TWEED
SHIRE COUNCIL

Planning and Regulation Reports **Ordinary Council Meeting** **Tuesday 20 September 2011**

6 [PR-CM] Department of Planning Application MP06_0153 at Lot 156 DP 628026; Creek Street, Hastings Point for a 45 Lot Residential Subdivision (Council Reference DA10/0228)

The Department of Planning have received a Preferred Project Report (amended application) for a 45 lot residential subdivision at Lot 156 Creek Street, Hastings Point (Concept Plan only). Council has been provided with an opportunity to comment on this application whilst part of on public exhibition (19 August 2011 – 5 September 2011).

proposed development layout 2011

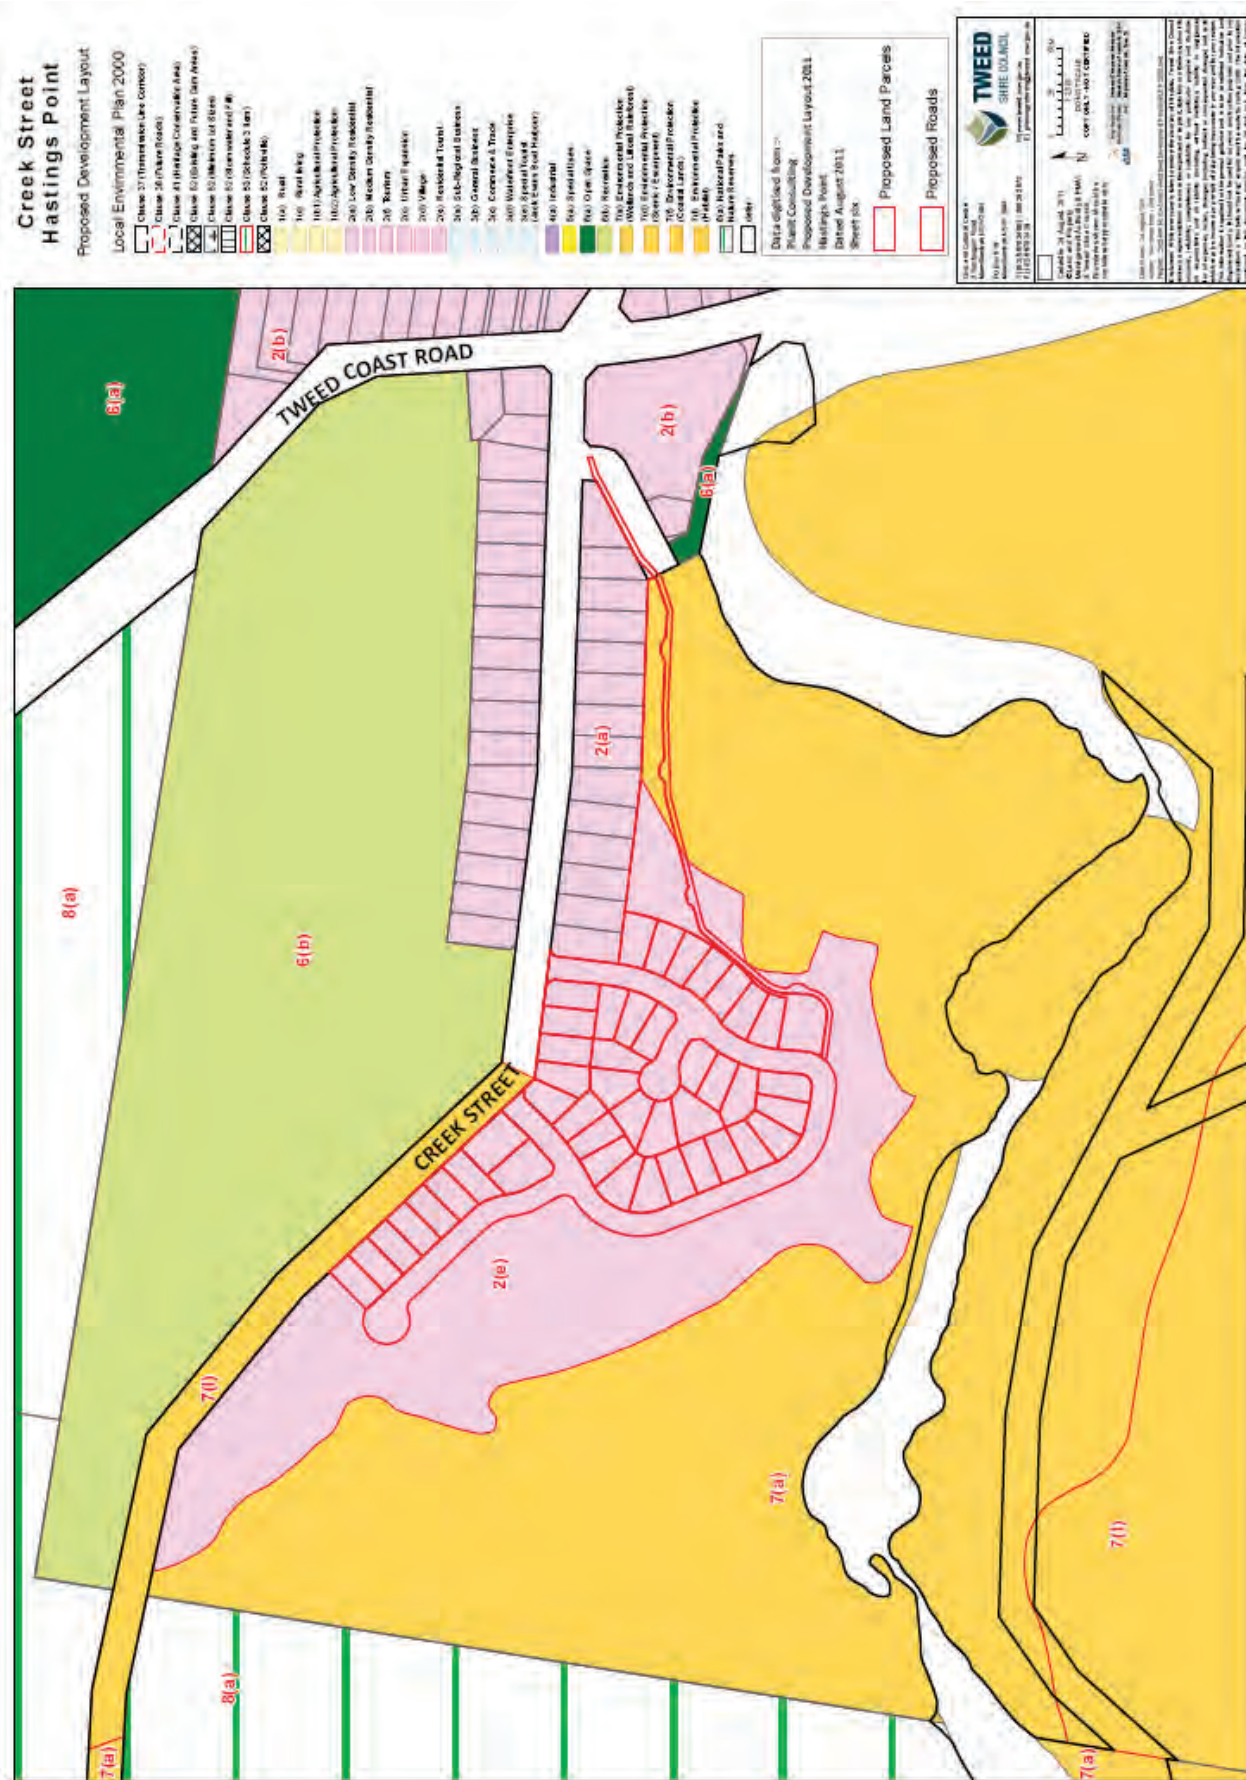
The amended proposal has been reviewed by Council staff and based on this review the application is still considered to warrant refusal by the Department of Planning and Infrastructure on the following primary grounds;

- The application fails to adequately consider the sensitive ecological status of the subject site;
- The proposed subdivision layout has not been designed in response to an adequate site analysis;
- The application fails to comply with the Tweed DCP Section B23 Hastings Point;
- The application fails to adequately integrate with the existing development and would create an unacceptable amenity outcome for existing residents in the locality;
- The application includes an emergency access road which is not considered to be justified in the 7(a) Environmental Protection (Wetlands and Littoral Rainforest) zone and fails to satisfy the provisions of Clause 8(2) of the Tweed LEP 2000; and
- The application represents a massive overdevelopment of a highly sensitive site.

Figure 3: Nature Reserve/Crown/Council surrounding the site.

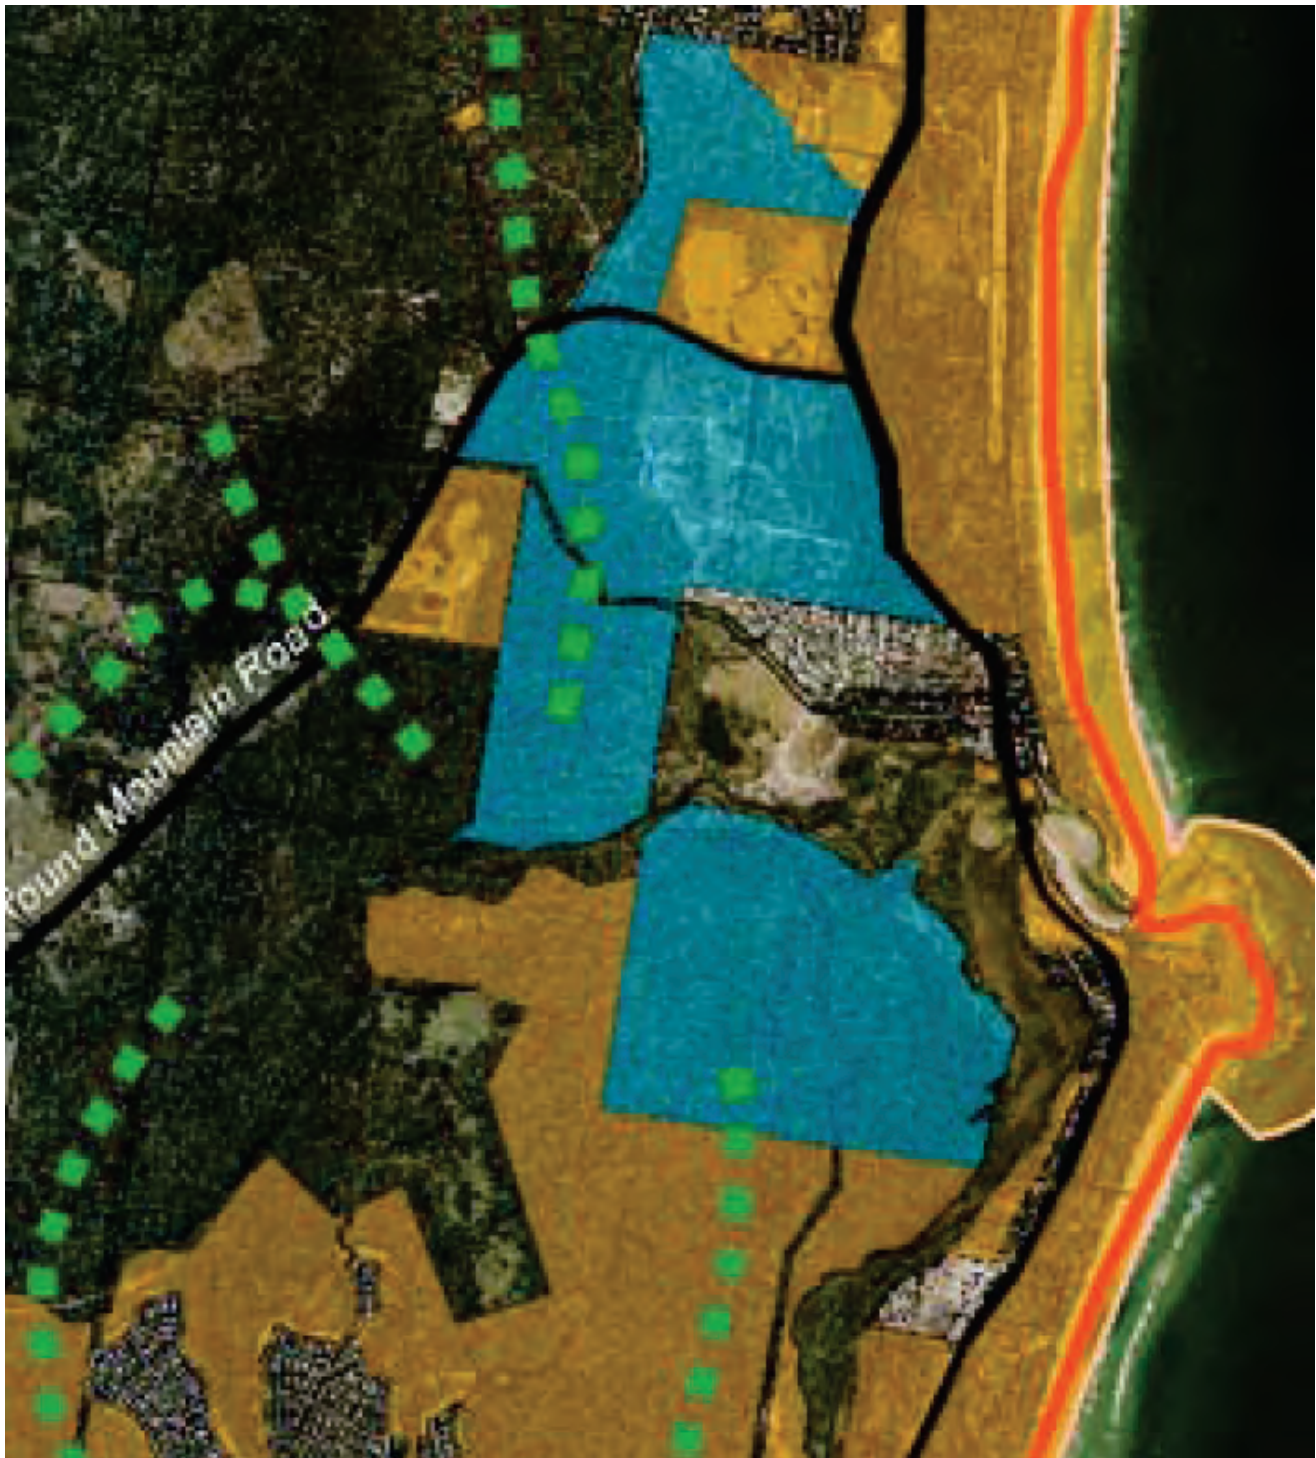
- Within 20m of mapped SEPP 14 (eastern edge);
- A Wildlife Atlas record for Black-necked Stork on the property (northern part of site);
- Surrounded by Nature Reserve to the south, west and north and estuary to the east (see Figure 3 below);
- Containing land of *very high* ecological value and *high* ecological sensitivity and
- Ranked within the top 100 (No. 28 in W1 overall category) of some 500 wetland and riverine ecosystems in the Tweed studied as part of the Comprehensive Coastal Assessment process (DEC 2006).

According to Figure 1 above, which shows a 50m buffer to mapped areas of saltmarsh and other riparian vegetation (but does not include mapping of large areas of mangrove forest), there is considerably overlap between the development footprint and a 50m development buffer. The current application is able to achieve this minimum whilst retaining a reasonable development footprint.

Figure 1: The approximate extent of clearing is outlined in red, with SEPP 14 and 100m buffer shown as blue hatching and environmental protection zoning extent as black line.

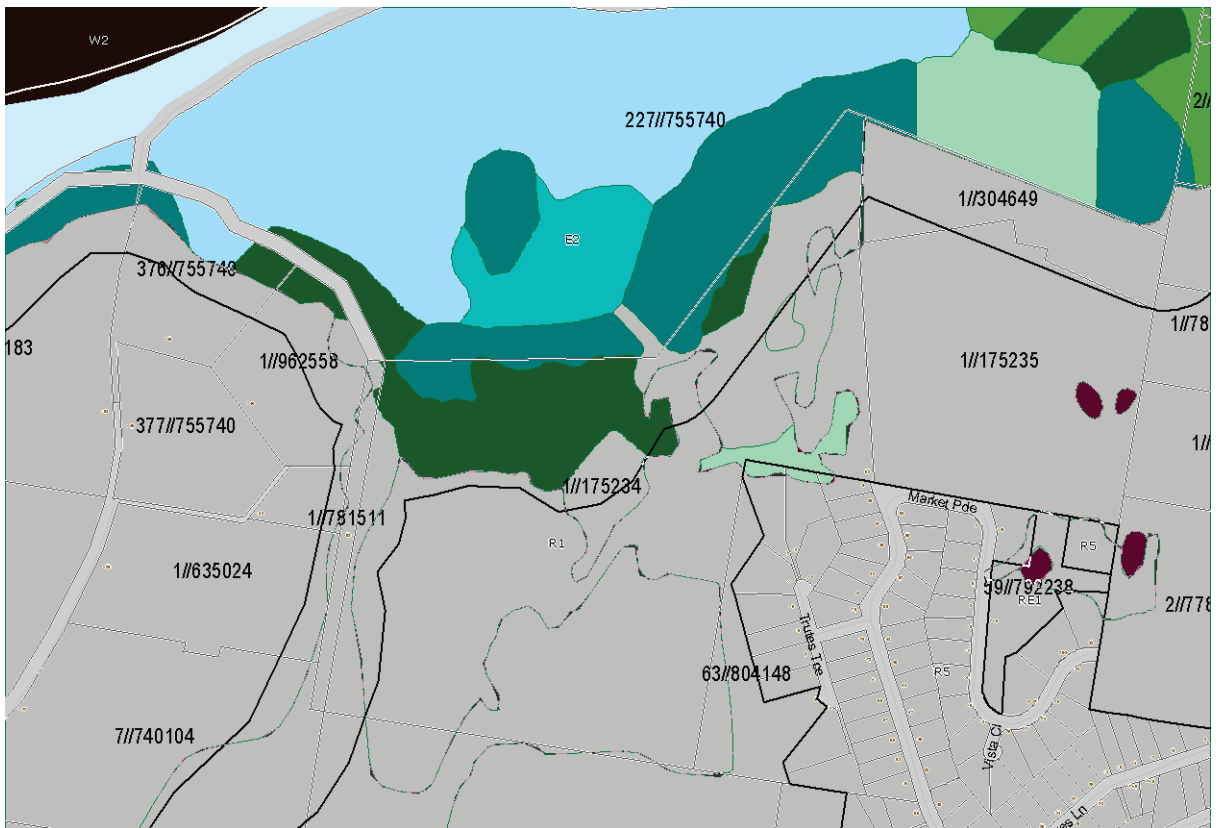
1. Bare ground without cover was present over much of the top section of the property (see Figure 1) and at least three large stockpiles of trees were visible. Trunks and leaves seen within these piles were primarily identifiable as Camphor Laurel (a noxious weed) with some pruned material (Lilly Pilly) confirmed as originating from a neighbour's hedge.
2. In other sections of the site some felled native trees were visible including Macaranga (*Macaranga tanarius*), Guioa (*Guioa semiglauca*), Red Kamala (*Mallotus philippensis*) and Rough-leaved Elm (*Apananthe philippinensis*).

3. No measurements were taken to be certain as to whether these native trees were greater than 3 metres in height or greater than 30cm in girth, but it was estimated that they were likely to be around that size or less, rather than substantially greater. Native trees of larger size were still present on the site dotted across the hill slope and marked with pink ribbon.
4. Whether any understorey species that may constitute threatened species had been cleared is not known, but no evidence of this was seen.
5. No Camphor Laurel removal or other vegetation clearing had been undertaken within the 7(a) Environmental Protection – Wetlands and Littoral rainforest zone (such works require development consent).
